Title		
Size A4	Number	Revision
Date:	2018-06-11	Sheet of
File:	C:\Users\...\dac-layout.SchDoc	Drawn By:

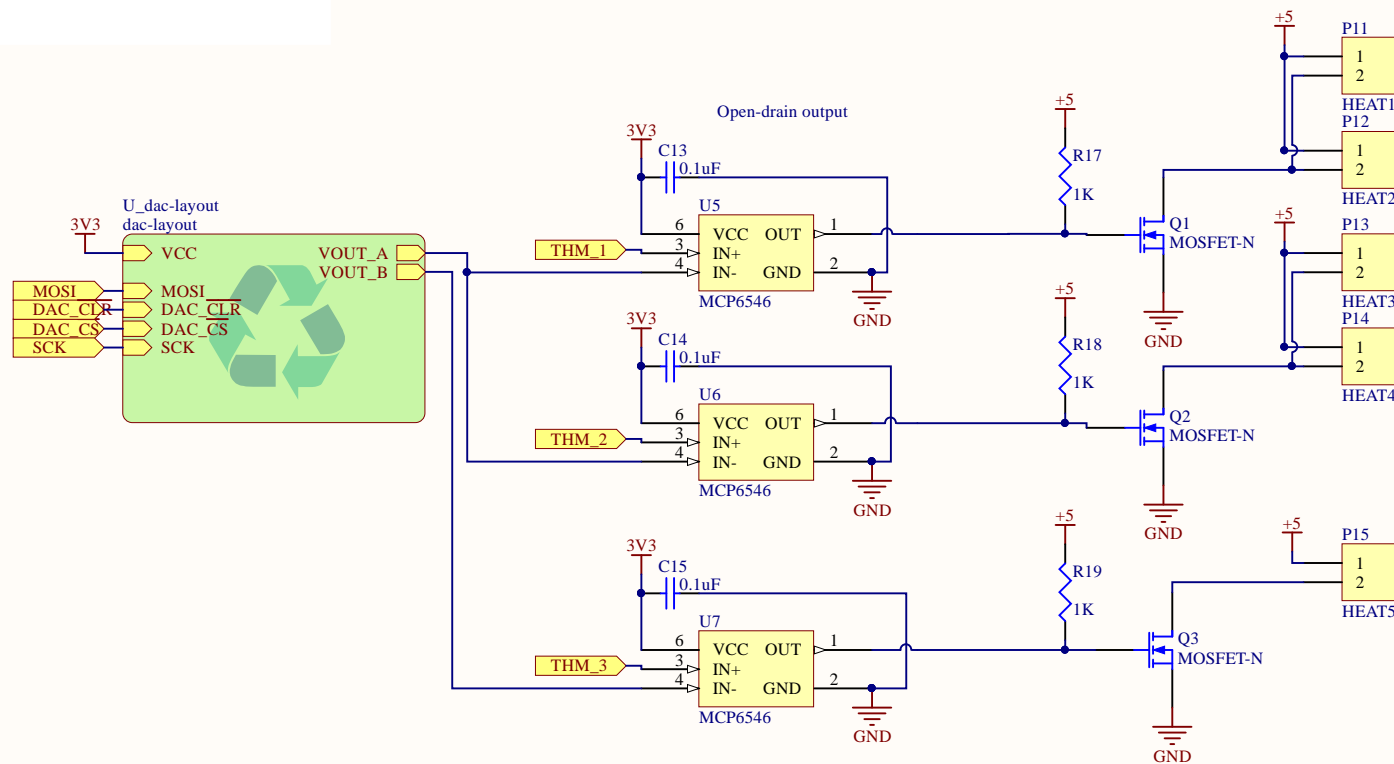
- Add DAC for voltage setting

Title		
Size A4	Number	Revision
Date:	2018-06-11	Sheet of
File:	C:\Users\...\power2V5.SchDoc	Drawn By:

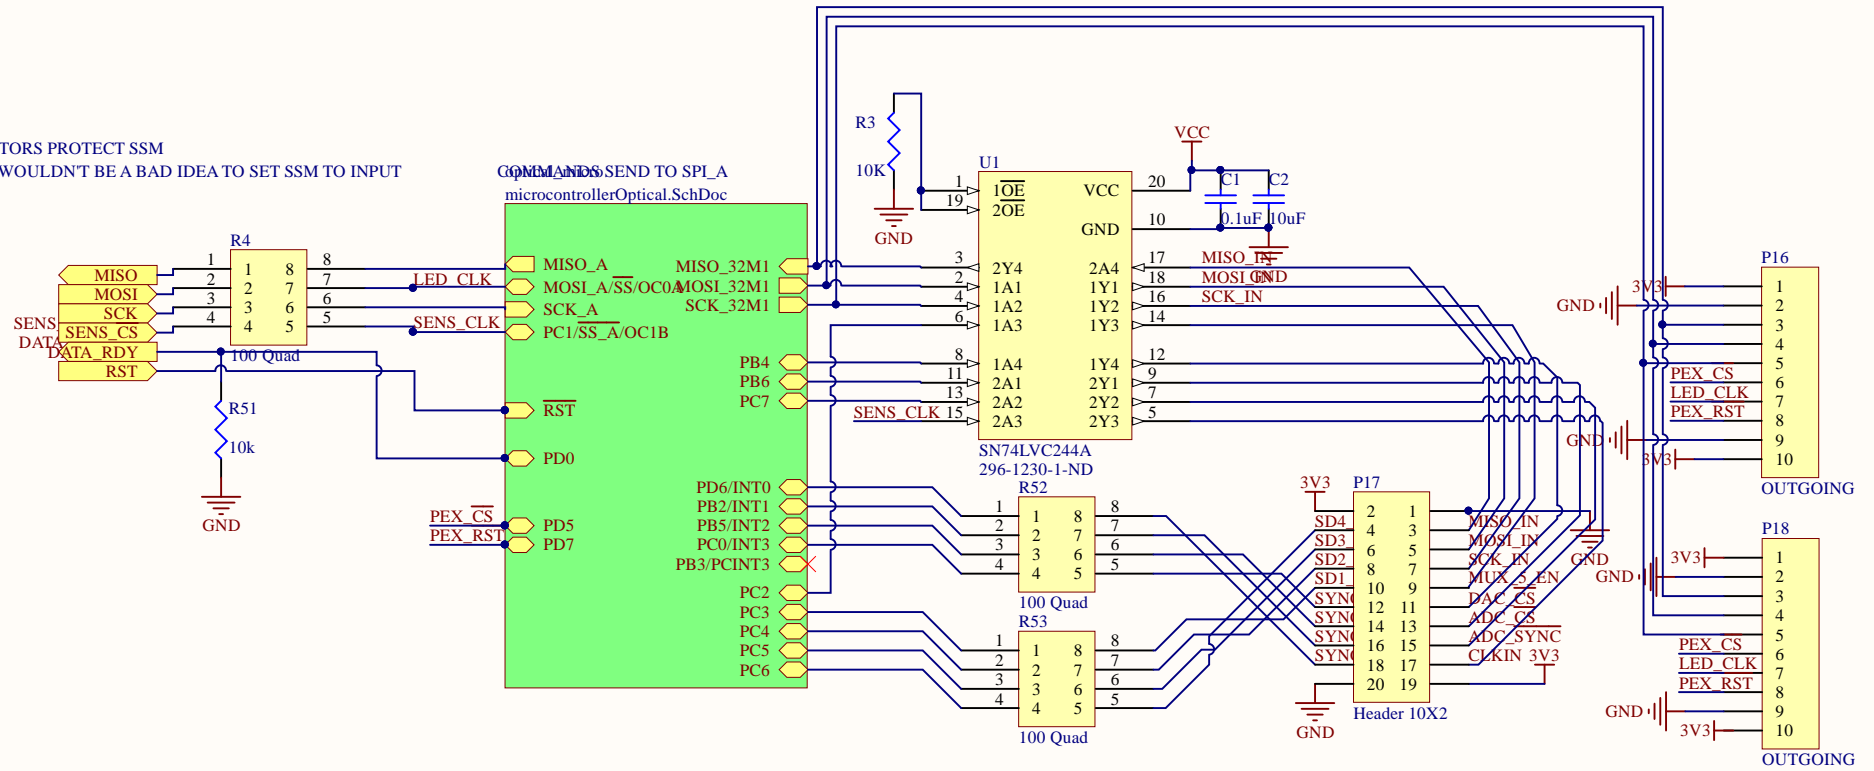
LIMIT RESISTORS PROTECT SSM
THAT SAID, WOULDN'T BE A BAD IDEA TO SET SSM TO INPUT

CHANGE THIS TO NET NAMES, ADD FOOTPRINT

Title		
Size A4	Number	Revision
Date:	2018-06-11	Sheet of
File:	C:\Users\...\thermistorADC.SchDoc	Drawn By:

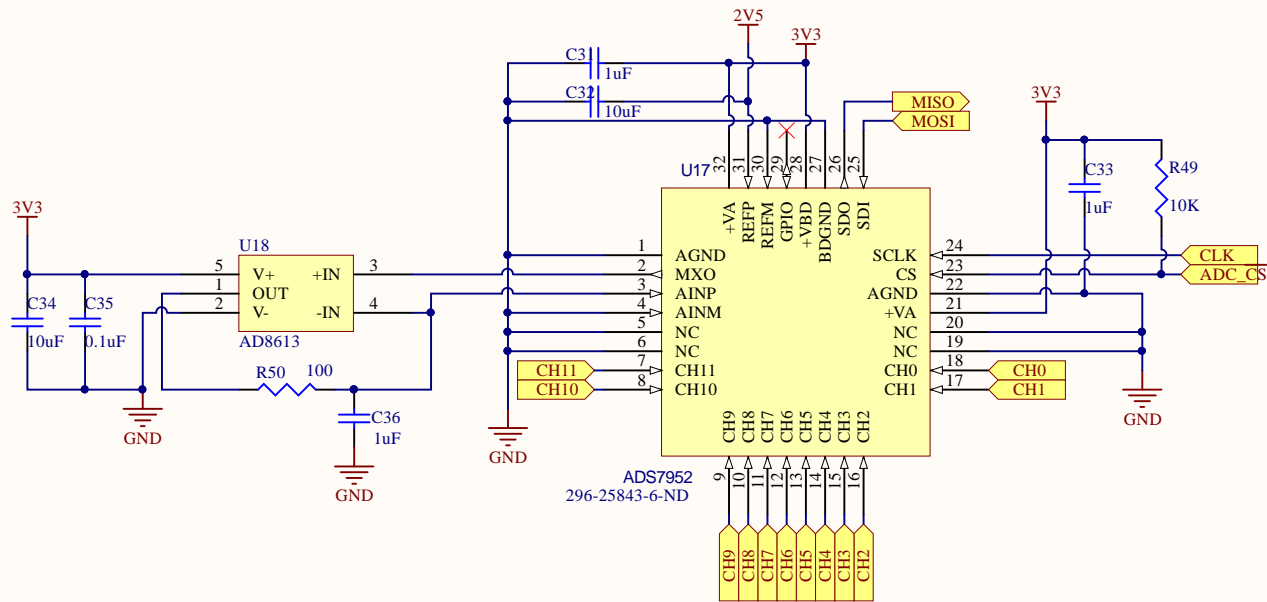
▲ Cap as close as possible to REFP and AGND

▲ See 10.1.1 of datasheet about connecting MXO and AINP. This limits the ADC to only work with input impedances of 50 ohms and less. If that is too restrictive, need to add a buffer here.

On second thought, 10.2.3. seems to suggest that at low enough sample rates high source impedances won't cause much issue.

▲ NR connected as in Figure 44 in 12.2
